National Highways Planning Response (NHPR 24-01) Formal Recommendation to an Application for Planning Permission

Council's Reference: PA/2023/421

Location: VPI Power Station, Rosper Road, South Killingholme, DN40 3DZ

Prepared for: Simon Geoghegan
Prepared by: Joshua Bell
Date: 15th April 2024
Case Reference: DevHU0163
Document Reference: DevHU0163 004 TM
Reviewed/approved by: Terry Dale

Figure 2. A160 / Eastfield Road Junction²

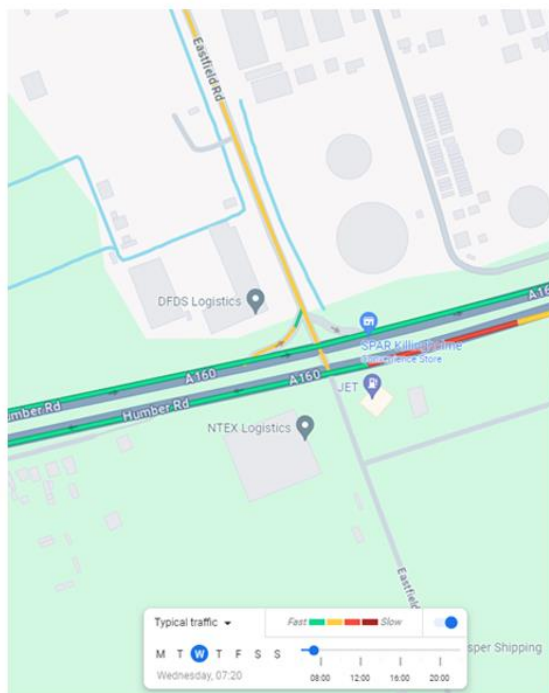
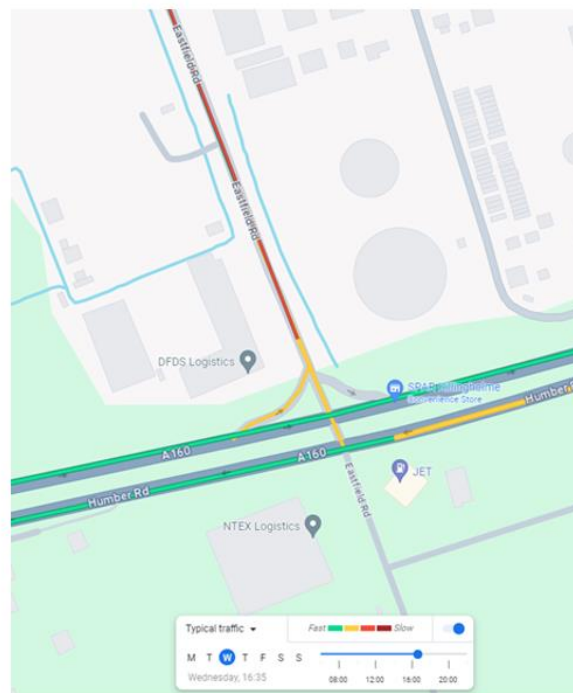
The typical traffic conditions from Google Maps indicate that A160 / Eastfield Road junction experiences queueing during the AM and PM peak hours, as shown in **Figure 2**. The junction will see 234 and 243 additional trips in the AM and PM respectively.

- A160 (east) – lane lengths, widths and radii are satisfactory;
- Eastfield Road (south) – lane length is input as 3.7 passenger car units (PCU), our understanding is that this should be coded as a full lane of length 60 PCU;
- A160 (west) – lane lengths, widths and radii are satisfactory;
- Eastfield Road (north) –
 - lane 4/1: length and width are satisfactory; radius should be revised to approximately 20m; and
 - lane 4/2: length is input as 11.8 PCU, our understanding is that this should be coded as a full lane of length 60 PCU, width is acceptable, right-turn radius should be revised to approximately 25m.
- Geometric parameters are being used to calculate saturation flows.

- Spot checks have been undertaken by the JSJV on the traffic inputs and these are seen to align with the traffic flow diagrams; and
- It is noted that the traffic flows are unusual with respect to the layout, for example during the PM peak the second highest movement at the junction is Eastfield Road (north) right-turn, which is catered for by only one lane shared with ahead movements.

- There has been no calibration and validation undertaken in association with the submitted LinSig outputs;
- There has been no queue data presented, queue data should be presented for the purpose of model calibration and validation; and
- The model should be reviewed to ensure that the queues on each lane align with the hourly average queues observed on each lane.

- With the existing green times, there is a significant impact on the Eastfield Road (north) ahead/right-turn arm during the PM peak, with the queue increasing from 27 PCU to 127 PCU as a result of the development;
- The assessment undertaken with revised green times for the PM With Development scenario shows the Eastfield Road (north) ahead/right-turn queue reducing from 127 PCU to 35 PCU;
- The aforementioned comments should be addressed and the assessment resubmitted; and
- In addition to the PDF output, the LinSig soft copy input file should be provided for review.

Figure

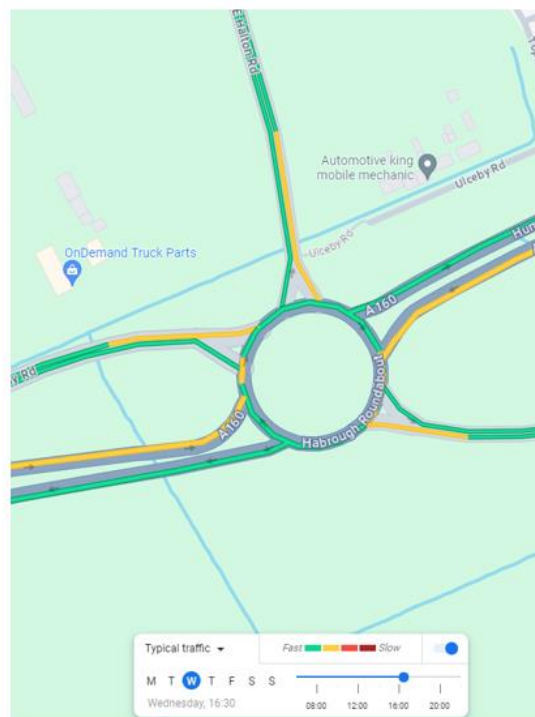
The typical traffic conditions from Google Maps indicate that Habrough Roundabout experiences minimal queueing during the AM peak hour, as shown in **Figure 3**. From a review of the traffic flow diagrams, it is noted that the junction will see 1 and 228 additional trips in the AM and PM respectively. We would request clarification on the AM figure.

- A160 (east) – we estimate half width to be 7.4m and entry width to be 8.4m, compared with 8.36m and 9.32m input in the model;
- Habrough Road – we estimate half width to be 3.9m and entry width to be 6.4m, compared with 7.43m and 9.04m input in the model;

- In the model, arms 1, 2 and 5 are provided with half width greater than 7m, however based on review of the traffic flows it appears that arms 1 and 3 are the two lane approaches (e.g. A160 east and A160 west);
- The above are examples of anomalies which have been noted, all geometric parameters should be reviewed; and
- All input geometry measurements should be shown on CAD PDF for review, adhering to the guidance in the Junctions 10 manual, measurements should reflect the road markings and not the entire available road surface.

- There is a significant impact on the A160 (west) arm during the AM peak, with the queue increasing from 23 PCU to 114 PCU as a result of the development;
- We expect the performance of the A160 (west) arm to improve given our recommendation regarding geometric parameters;
- The aforementioned comments should be addressed and the assessment resubmitted; and
- In addition to the PDF output, the Junction 10 soft copy input file should be provided for review.

Figure 4. Brocklesby Interchange⁴

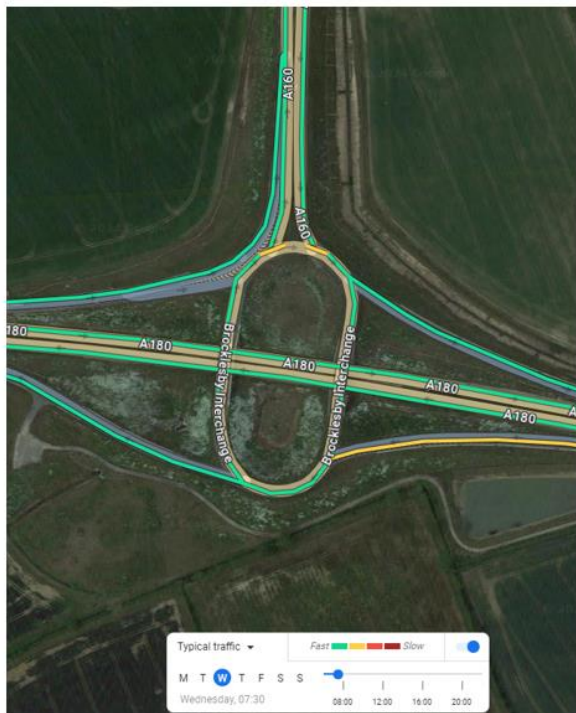
The typical traffic conditions from Google Maps indicate that Brocklesby Interchange experiences slow moving traffic during the AM and PM peak hours, as shown in **Figure 4**. The junction will see 185 and 232 additional trips in the AM and PM respectively.

- A160 Humber Road – we estimate half width to be 7.7m and entry width to be 8.6m, compared with 8.17m and 9.38m input in the model;
- A180 (east) off-slip – we estimate half width to be 3.5m and entry width to be 5.0m, compared with 8.3m and 8.99m input in the model – it is concluded this is a result of measurements including areas which are not available for drivers to use, such as areas beyond lane edge marking, this should be revised;

- Inscribed circle diameters are input at 163.8m, 373.6m and 325.2m for arms 1, 2 and 3 respectively, this should be revised to reflect on site dimensions;
- The comments are examples of anomalies which have been noted, all geometric parameters should be reviewed; and
- All input geometry measurements should be shown on CAD PDF for review, input geometry is required to reflect the road markings.

- The HV Percentages are set to 10% for each movement, this should be revised to reflect the traffic survey data;
- The traffic inputs show that arm 1 is the A160 Humber Road;
- A180 (west) off-slip bypass utilisation is set to 100%, this should be confirmed from the traffic surveys; and
- Spot checks have been undertaken on the traffic inputs which are seen to align with the traffic flow diagrams.

Figure 5. M180 Junction 5⁵

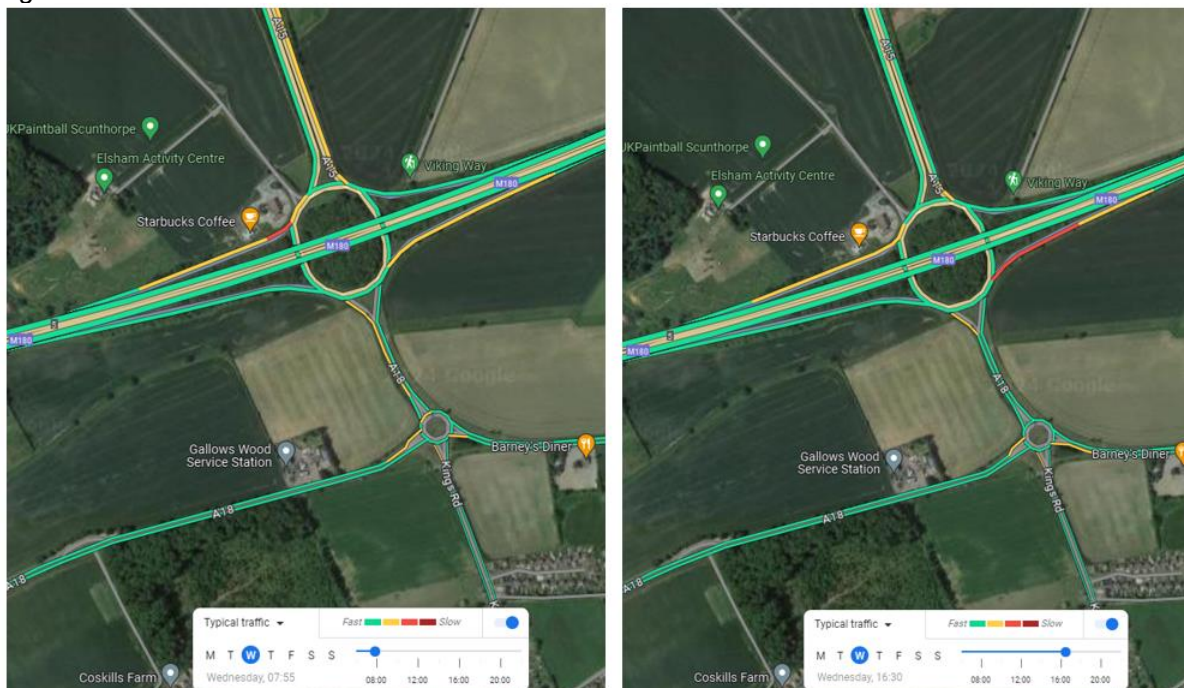
The typical traffic conditions from Google Maps indicate that M180 Junction 5 experiences queueing during the PM peak hour, as shown in **Figure 5**. The junction will see 103 and 83 additional trips in the AM and PM respectively.

- A180 (east) off-slip – we estimate half width to be 6.4m and entry width to be 7.2m, compared with 7.75m and 8.71m input in the model;
- M180 (west) off-slip – we estimate half width to be 6.0m and entry width to be 7.1m, compared with 6.6m and 7.88m input in the model;
- Inscribed circle diameters should be revised to reflect on site dimensions, for example arm 3 is input as 268.1m and we estimate this should be 153m;

- These are examples of anomalies which have been noted, all geometric parameters should be reviewed; and
- All input geometry measurements should be shown on CAD PDF for review, input geometry is required to reflect the road markings.

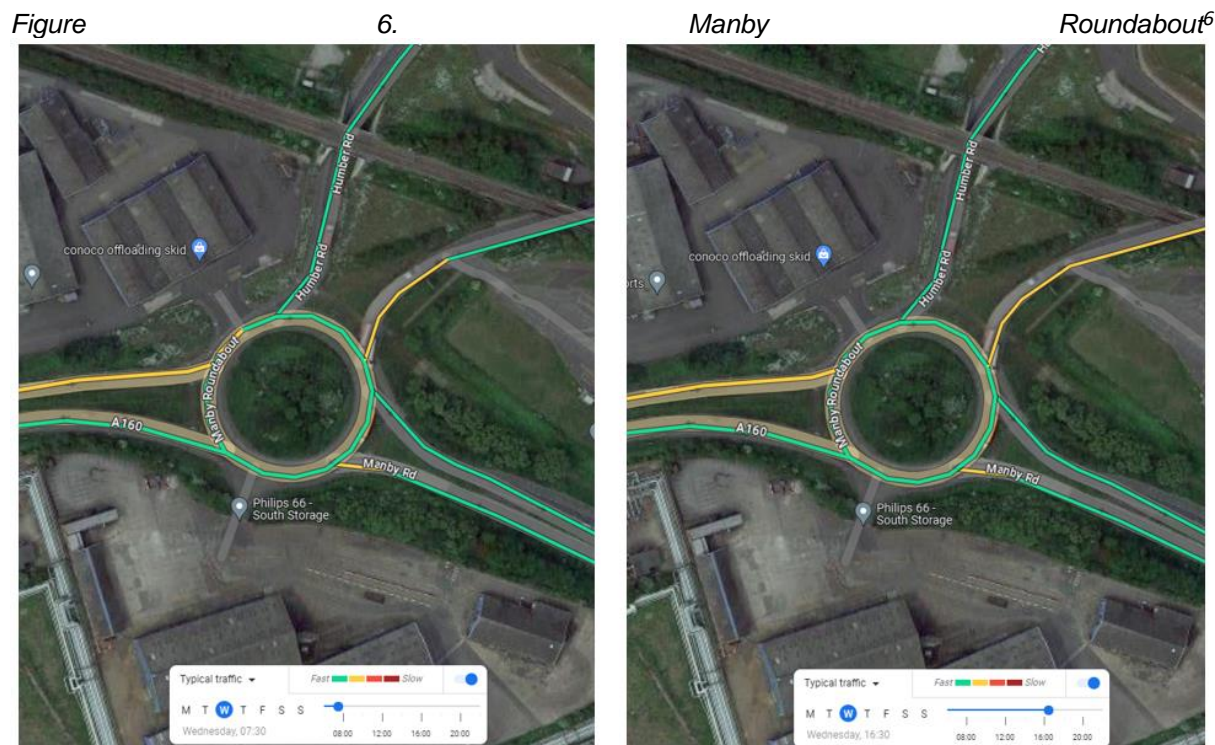
The typical traffic conditions from Google Maps indicate that Manby Roundabout does not experience significant queueing during the AM and PM peak hours, as shown in Figure 6. The junction will see 43 and 28 additional trips in the AM and PM respectively.

- Inscribed circle diameters should be revised to reflect on site dimensions, we estimate this should be 84m, currently different values are input for each arm, the roundabout is symmetric and these values should be consistent;
- These are examples of anomalies which have been noted, all geometry should be reviewed; and

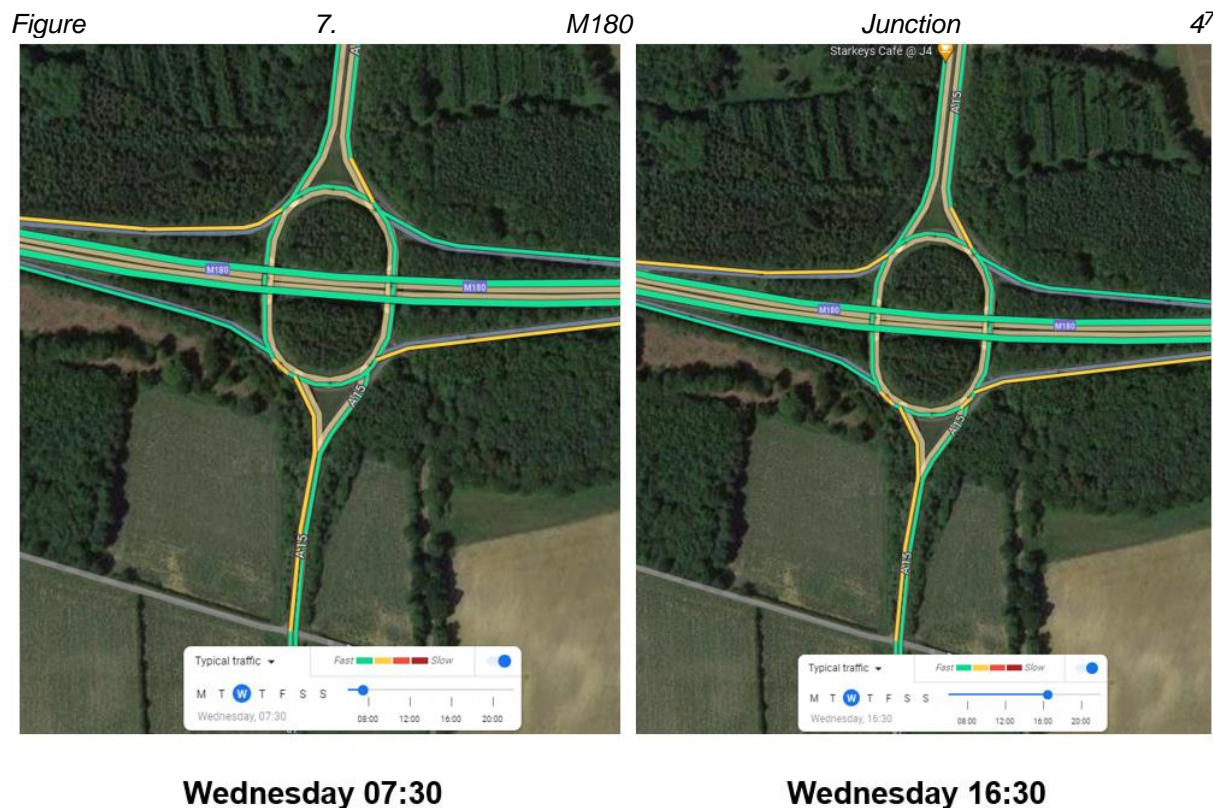
The typical traffic conditions from Google Maps indicate that M20 Junction 4 does not experience significant queuing during the AM and PM peak hours, as shown in **Figure 7**. The junction will see 44 and 43 additional trips in the AM and PM respectively.

- M180 (east) off-slip – we estimate half width to be 6.2m and entry width to be 8.3m, compared with 6.1m and 8.9m input in the model;
- M180 (west) off-slip – we estimate half width to be 6.0m and entry width to be 7.1m, compared with 6.6m and 7.88m input in the model;
- Inscribed circle diameters should be revised to reflect on site dimensions, for example arm 1 is input as 75.2m and we estimate this should be 114m;

- The junction is shown to operate within capacity in all scenarios, with the exception of arm 2 which is understood to be the A15 (south);
- The comments should be addressed and the assessment resubmitted; and
- In addition to the PDF output, the Junction 10 soft copy input file should be provided for review.
